COUNTAX™

SERVICE BULLETIN

09-T6-17

CONCERN: Thrust washer change on K62 & K66 Transmission

Figure 1: K62 & K66 Thrust washer kit

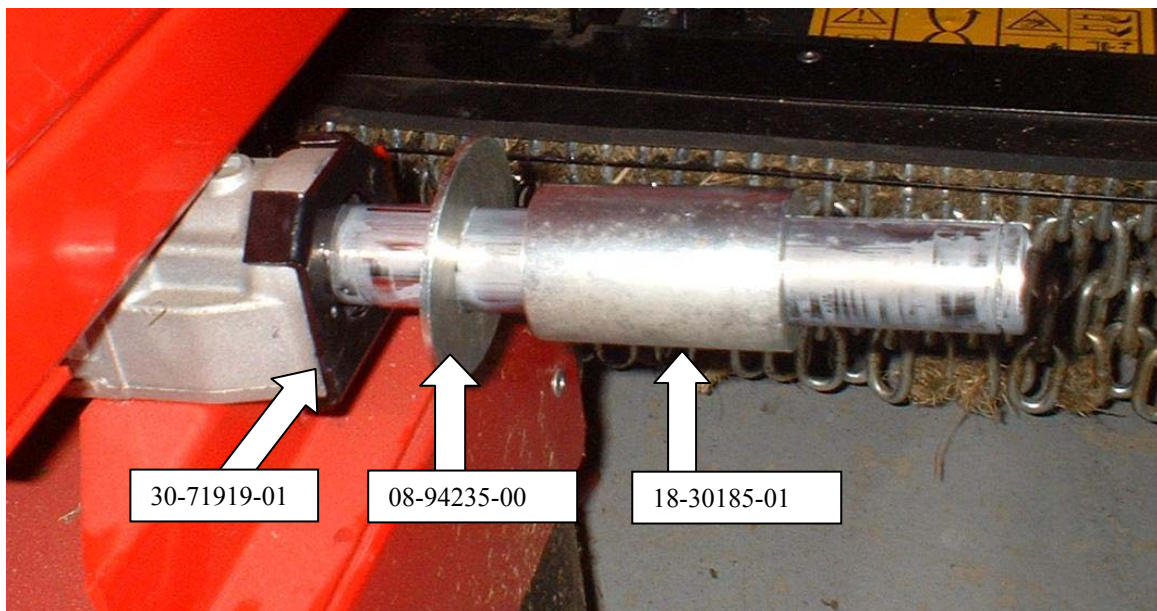
The Thrust washer is placed over the axle first (both sides), then the washer followed by the spacer as figure 1 shows. The wheel is then placed on as normal making sure a key is used and the axle is lubricated.
